MECHANICAL CONTRACTOR:
LRC CONSTRUCTION, LLC.
7 RENAISSANCE SQUARE, 4TH FLOOR WHITE PLAINS, NY 10601
PHONE: 914-773-7700
FAX: 914-946-1670

DRAWING NAME:
HVAC FIRST FLOOR SHOP DRAWING

PROJECT INFORMATION:
RXR WELCOME CENTER
507 Main Street
New Rochelle, NY 10801

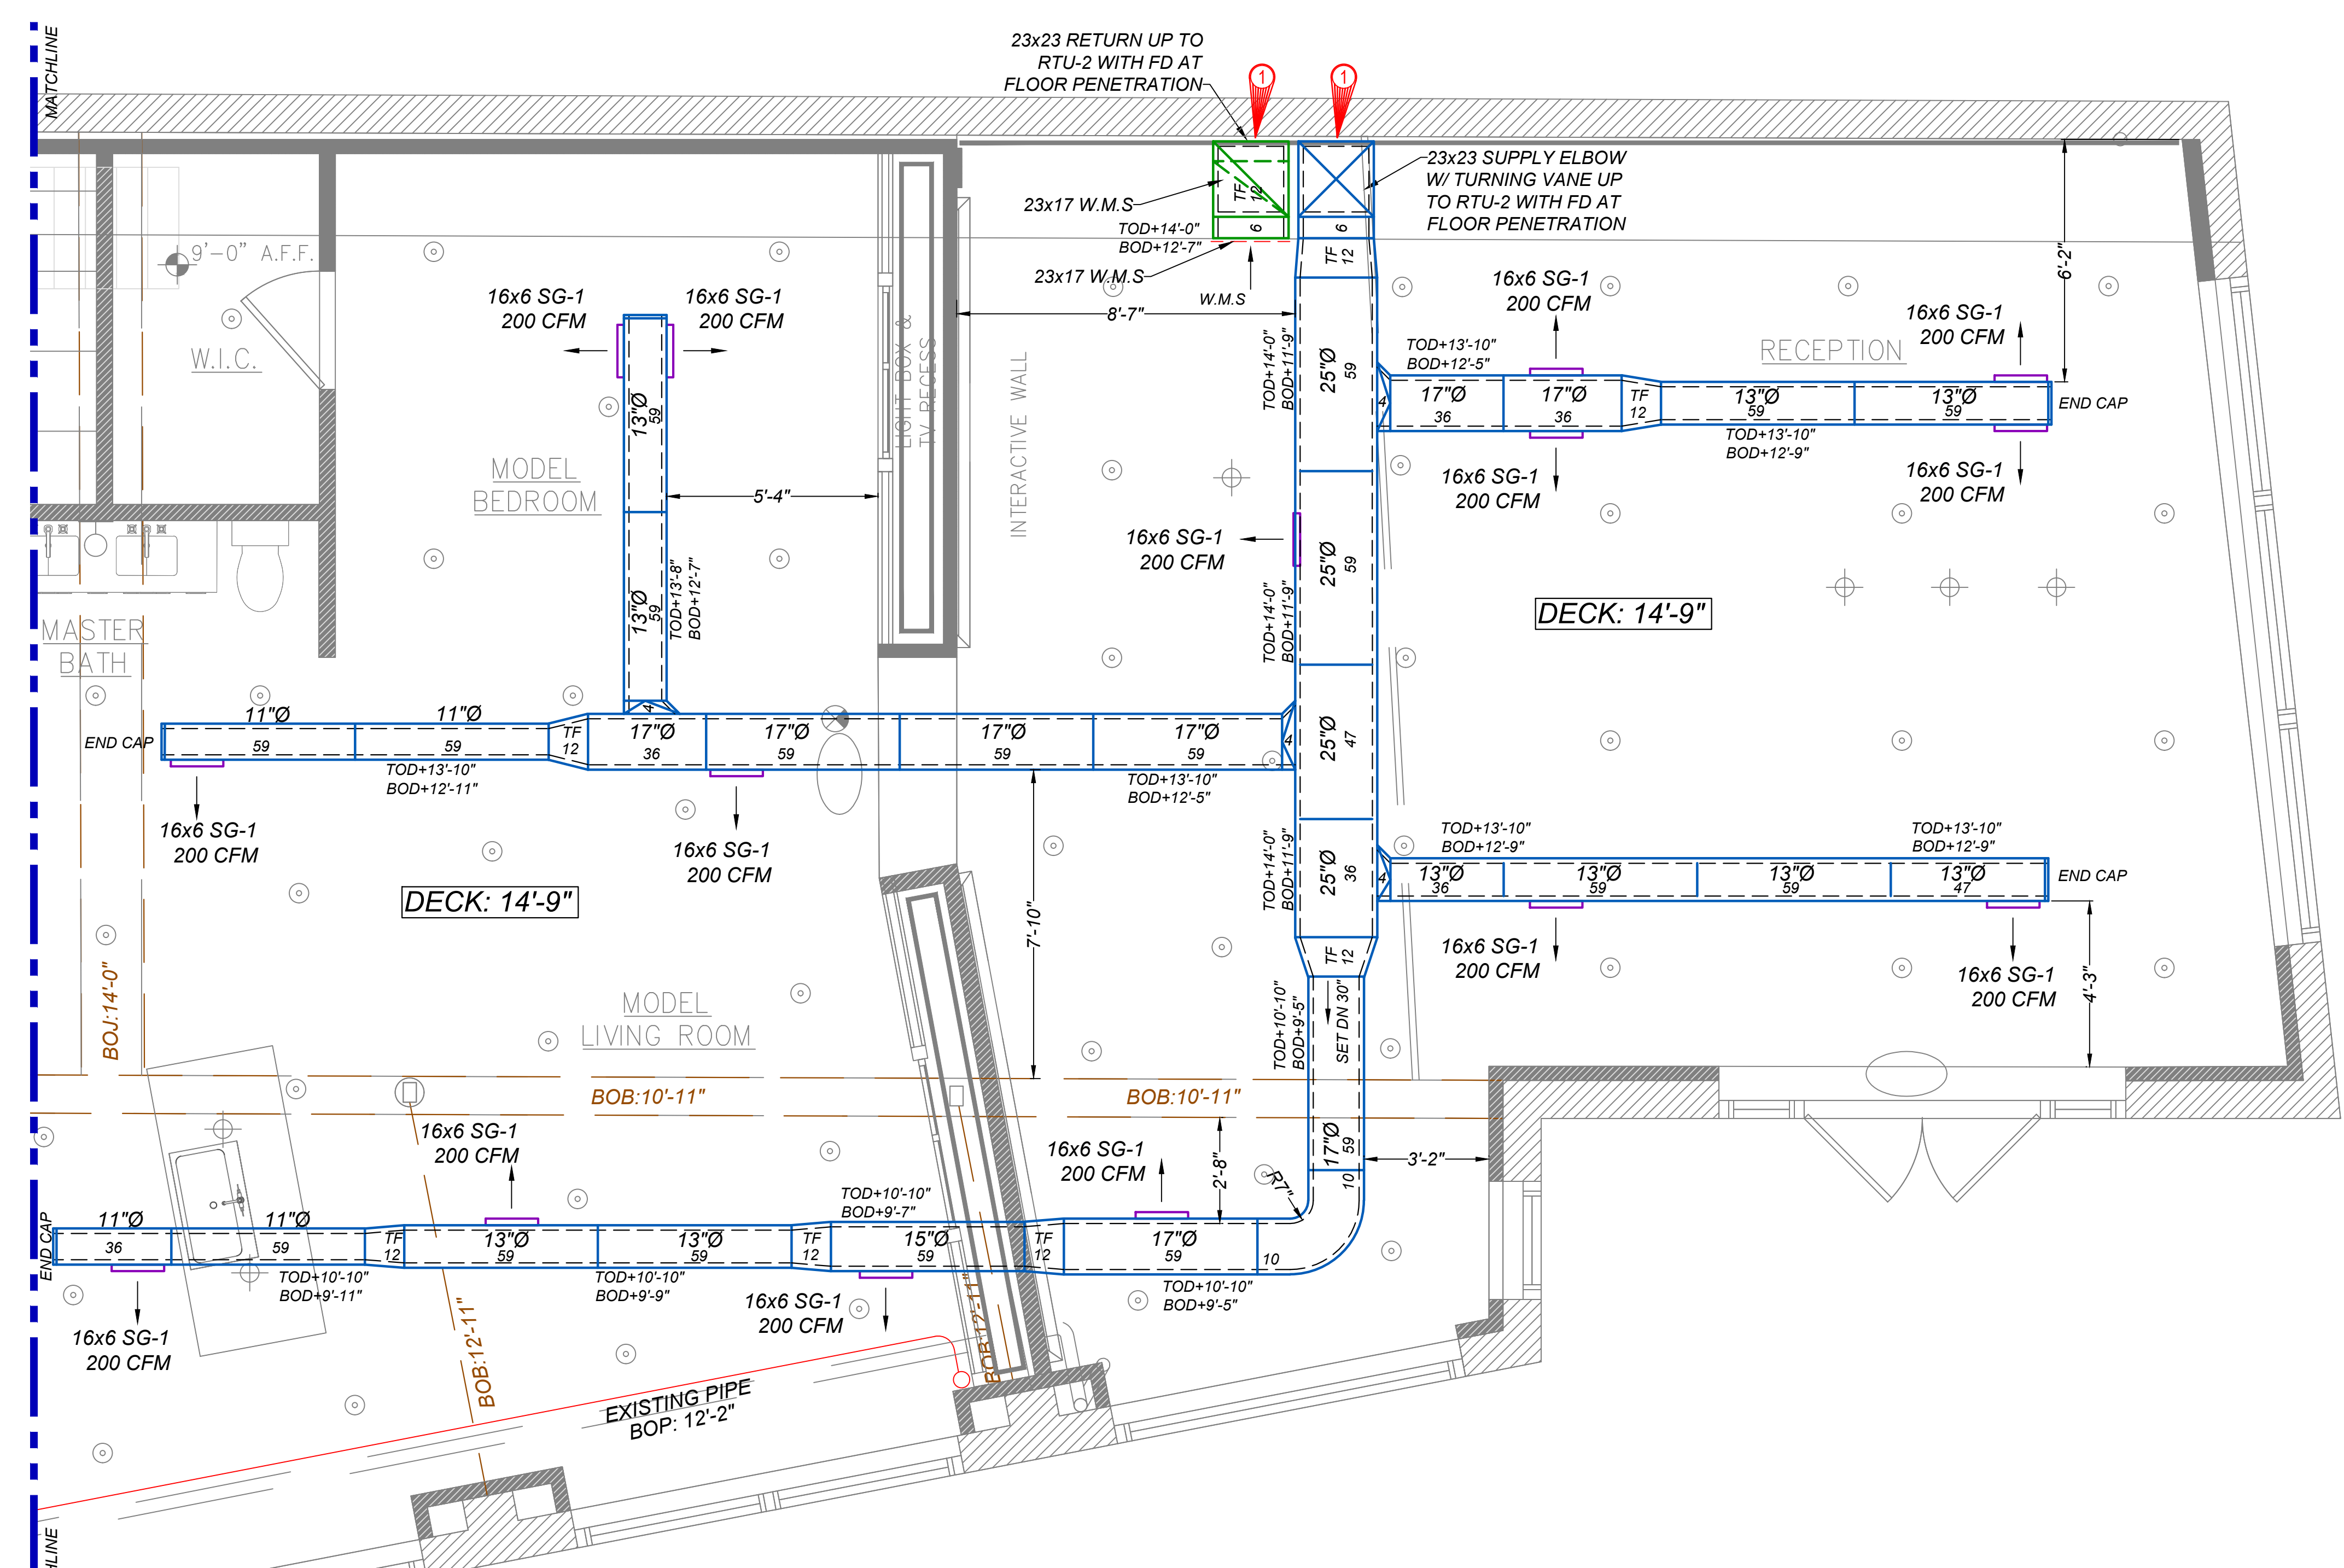
1. CONFLICTING WITH WALL. ENGINEER TO VERIFY.
2. CONFLICTING WITH SPRINKLER HEAD. ENGINEER TO VERIFY.

DRAWING NAME:
HVAC SECOND FLOOR SHOP DRAWING

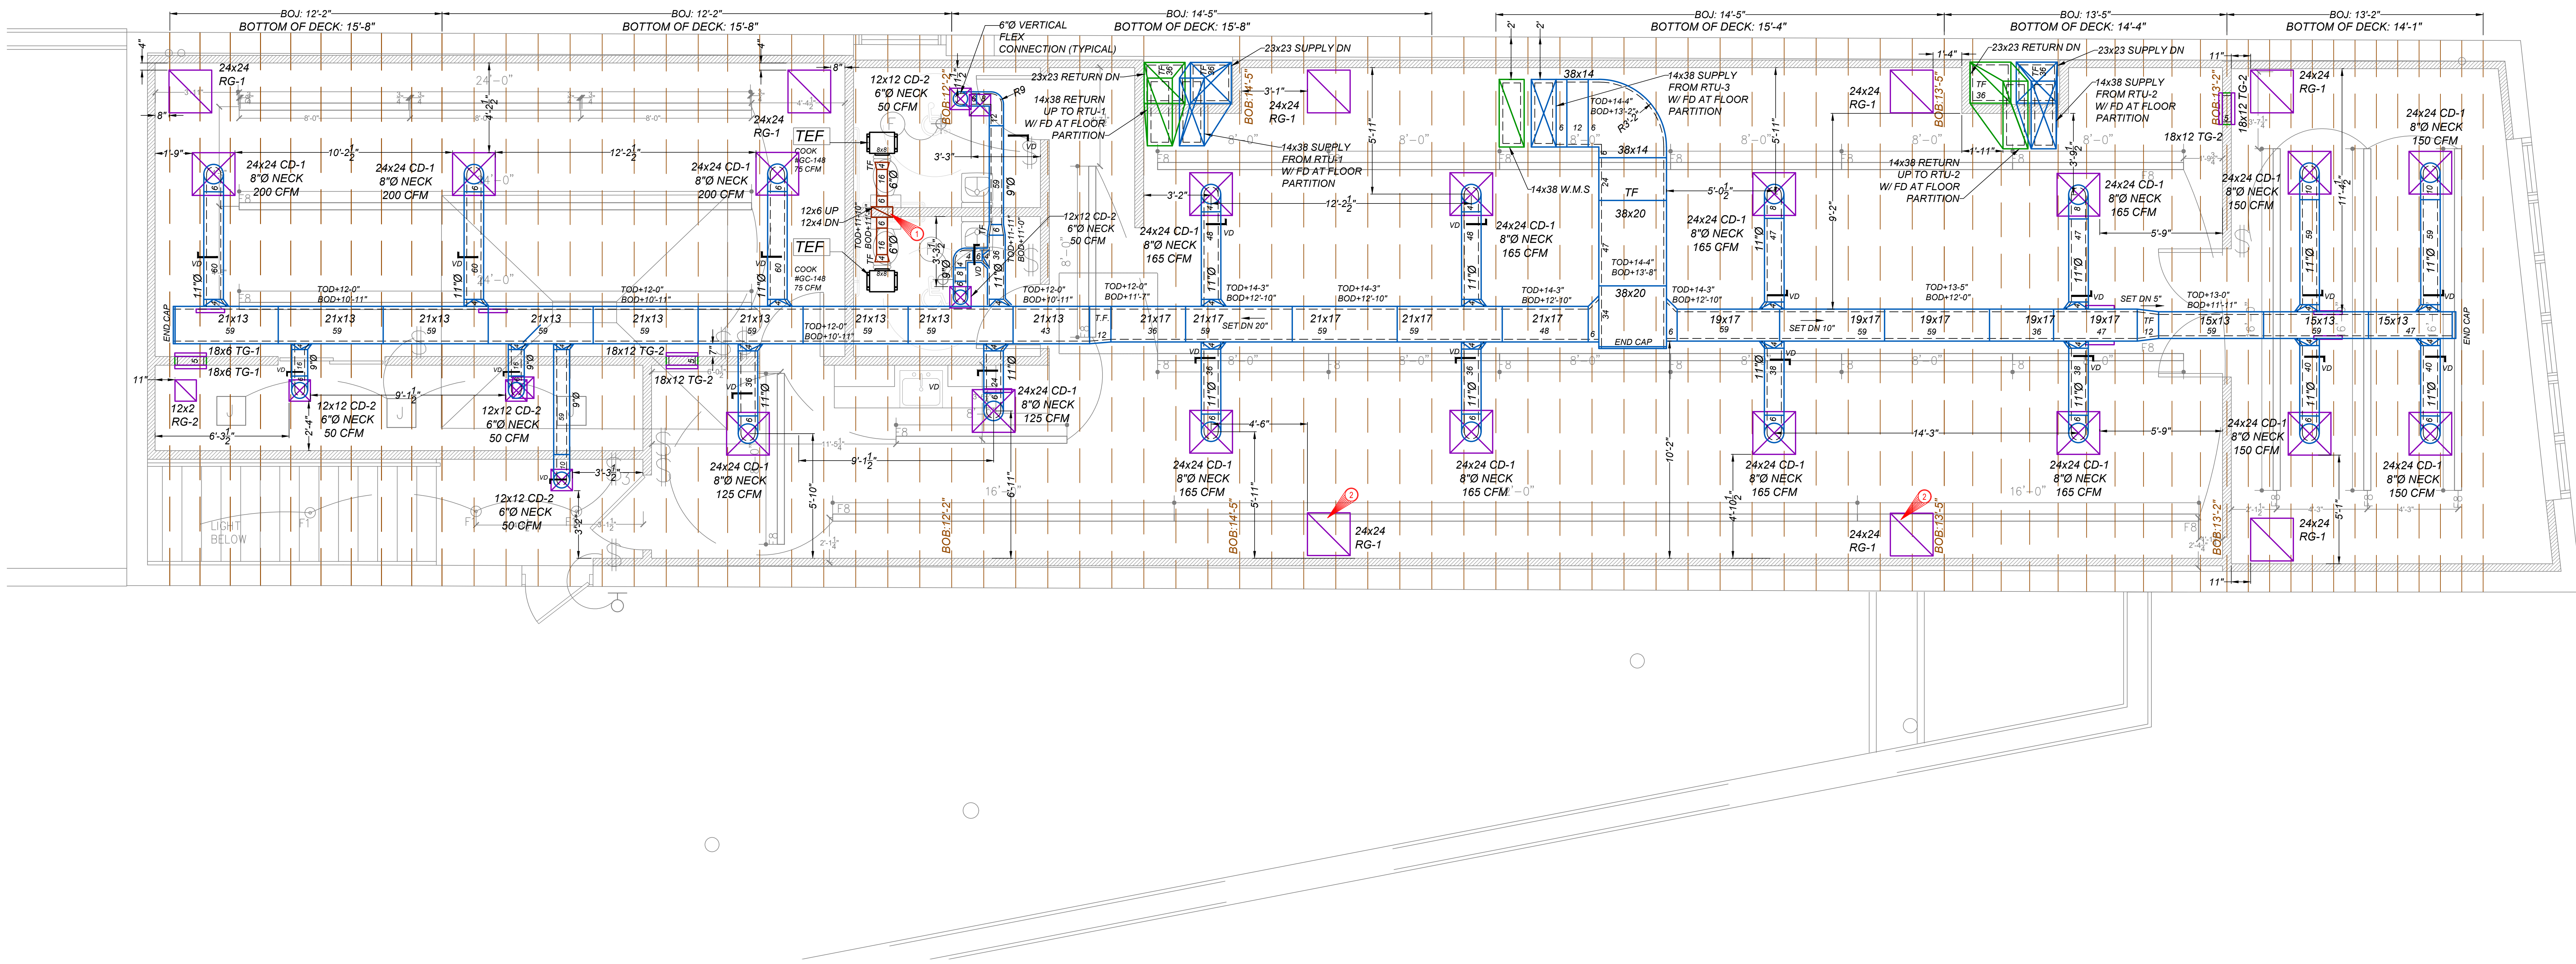
- 1 CONFLICTING WITH JOISTS. ENGINEER TO VERIFY.
- 2 CONFLICTING WITH LIGHT. ENGINEER TO VERIFY.
